## **BID ADDENDUM NO. 4**

October 01, 2018

### **Johnson Student Center**

### **Building Demolition, Increment 1 (Demolition) and Increment 2**

DATE:	09/18/2018		
FROM:	S.Monsen - McCarthy	EMAIL:	SMonsen@McCarthy.com
SPECIFICATION NUMBER:		DRAWING NUMBER:	Sheet C5.2

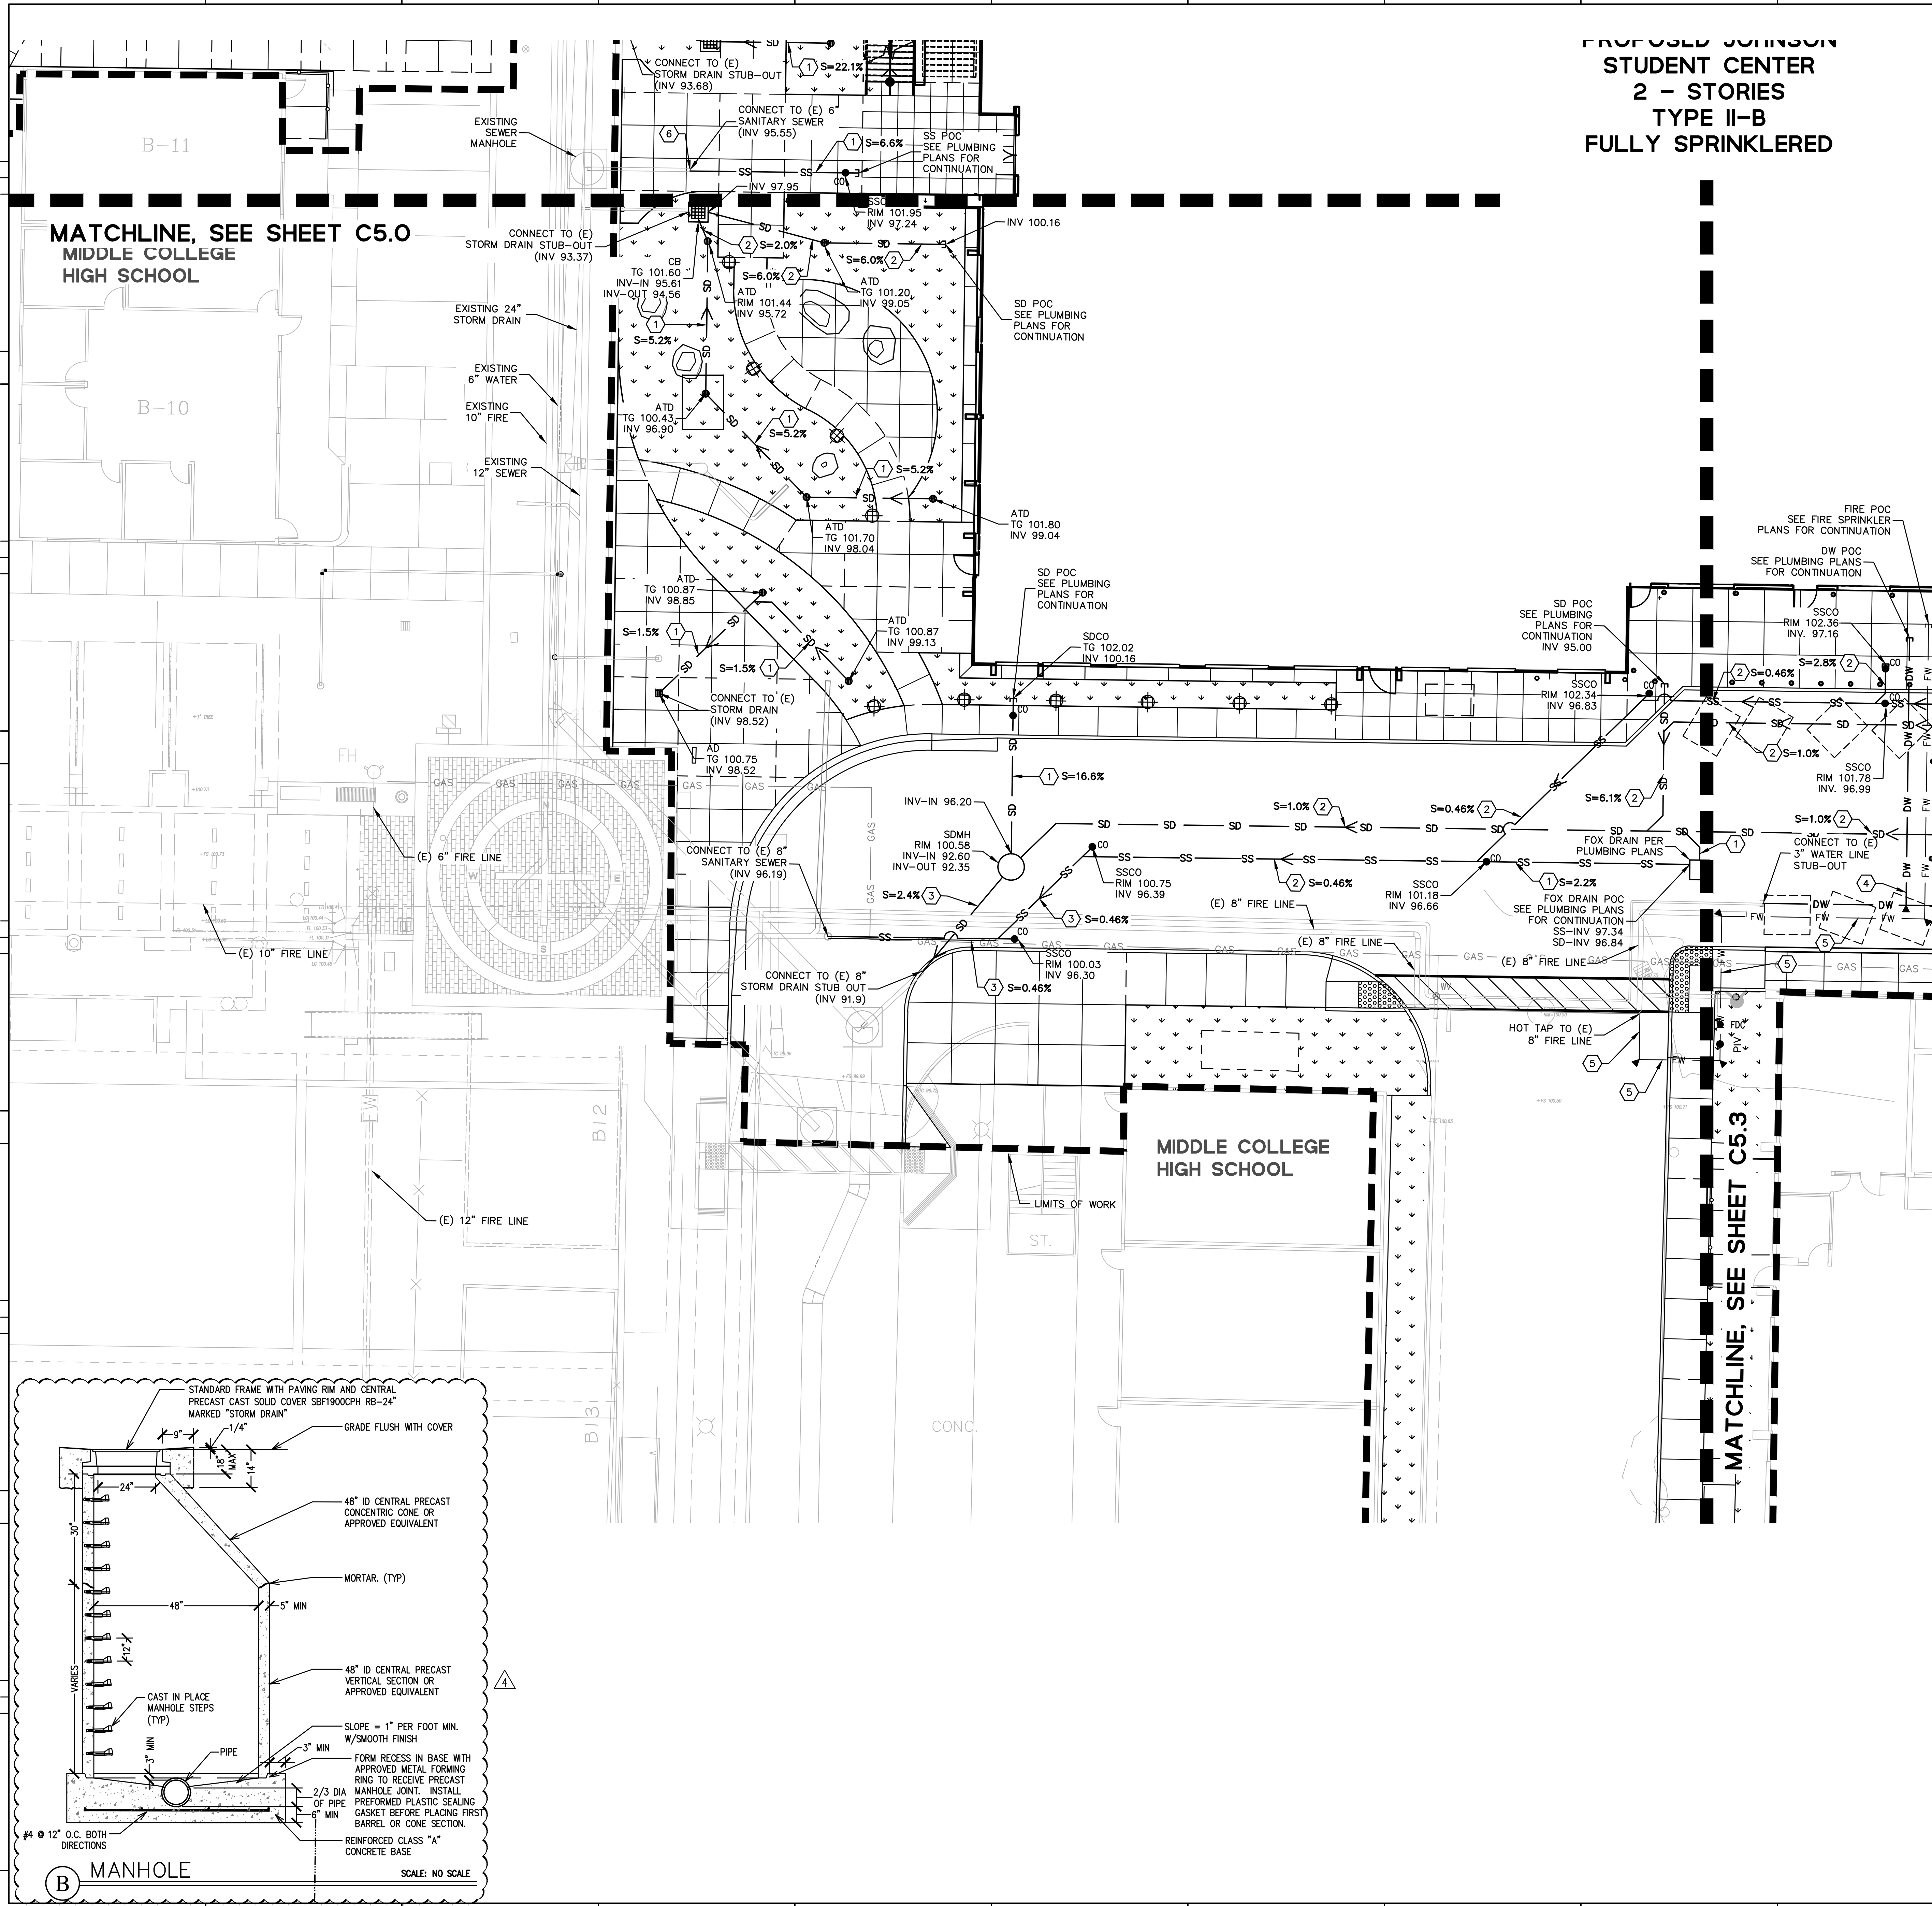
Increment #2 - Sheet C5.2 (lower-left) - The callout for the SDMH (RIM 100.58) does not appear on the Utility Legend nor does it have a detail referenced. Please confirm that this Storm Drain Manhole is to be included & provide a detail for this structure, or confirm that this is existing and to be protected in place.

**Confirmed, Storm Drain manhole to be included. Detail B provided on sheet C5.2**

DATE:	09/18/2018		
FROM:	S.Monsen - McCarthy	EMAIL:	SMonsen@McCarthy.com
SPECIFICATION NUMBER:		DRAWING NUMBER:	C5.4

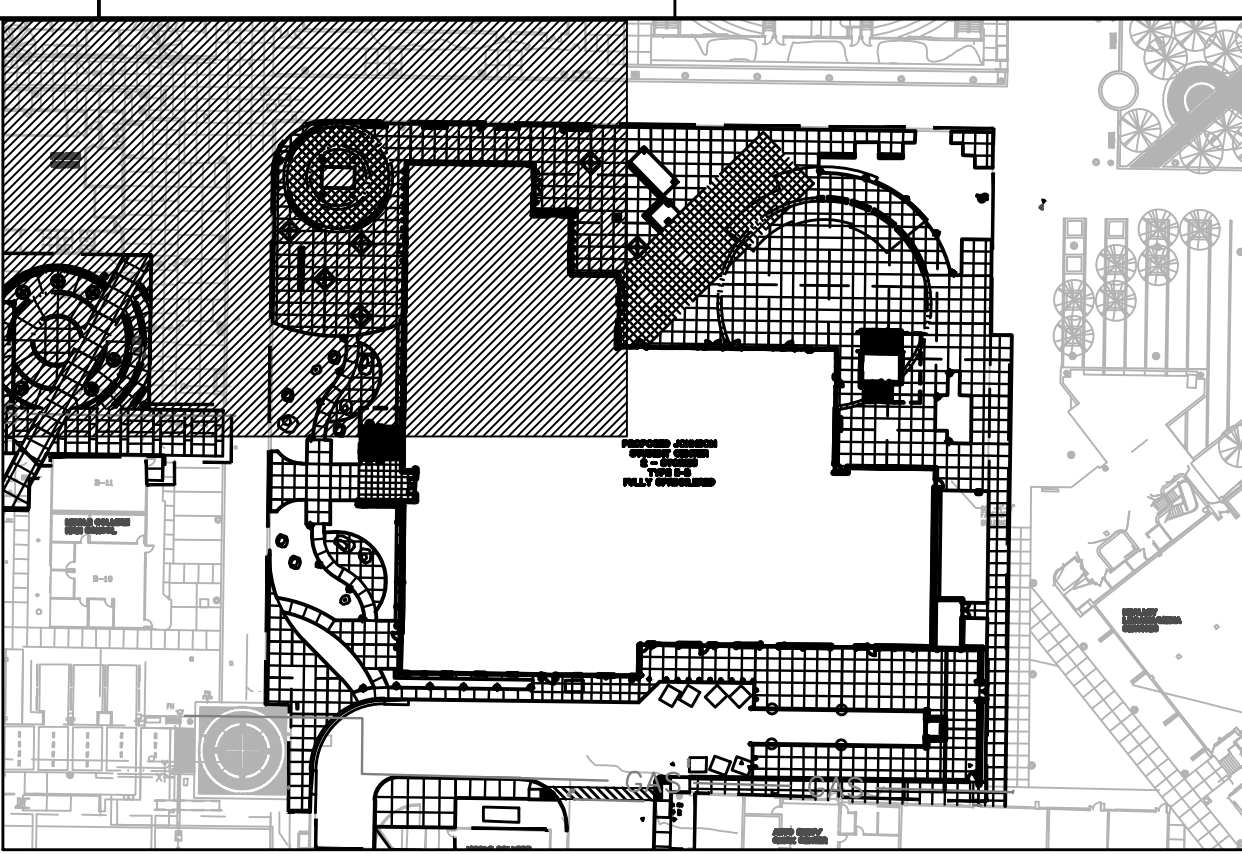
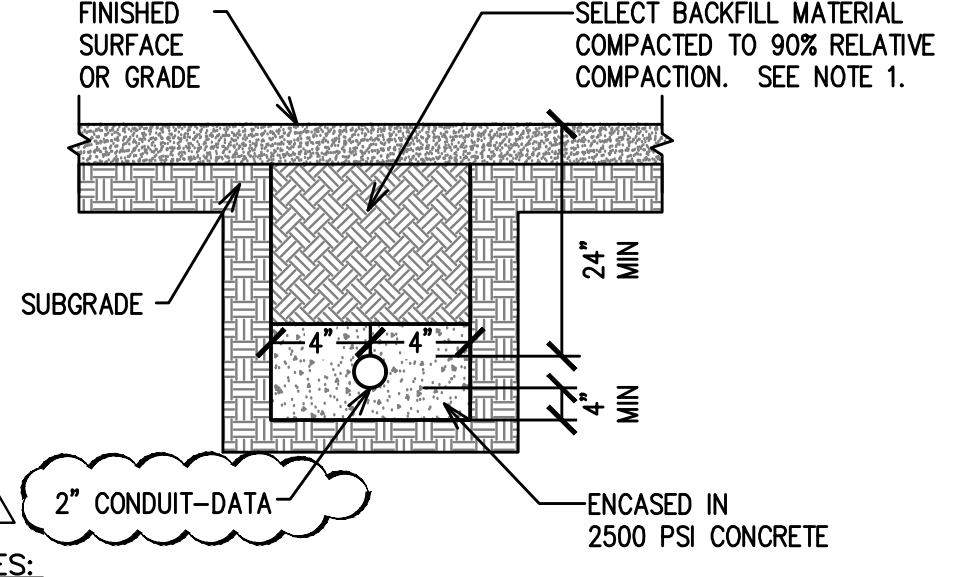
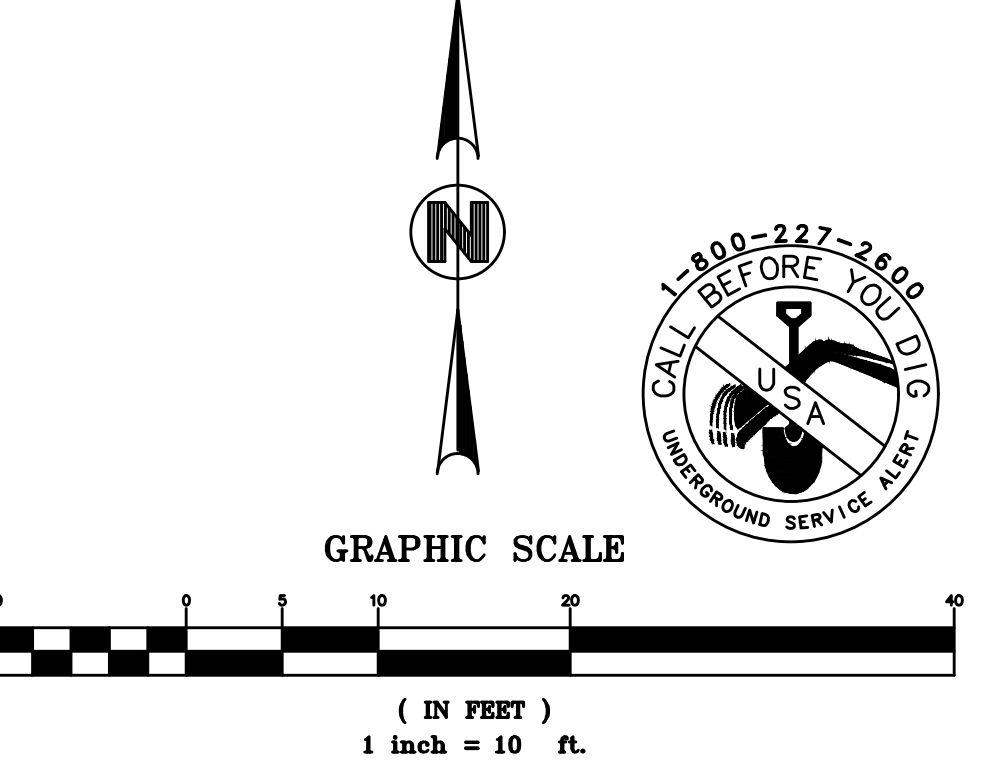
Increment #2 - Sheet C5.4 - The new SD pipe is beyond the Limit-of-Work line, please confirm that the bidders are to include cutting & patching of the existing hardscape. Please provide detailed information for this hardscape - thickness, finish, rebar size & spacing, as well as minimum dimensions for the

Confirmed, bidders are to include cutting & patching of the existing hardscape. Please utilize the same hardscape information as the proposed sidewalk for this project, as shown as the first item on the Pavement Legend on sheet C3.0.
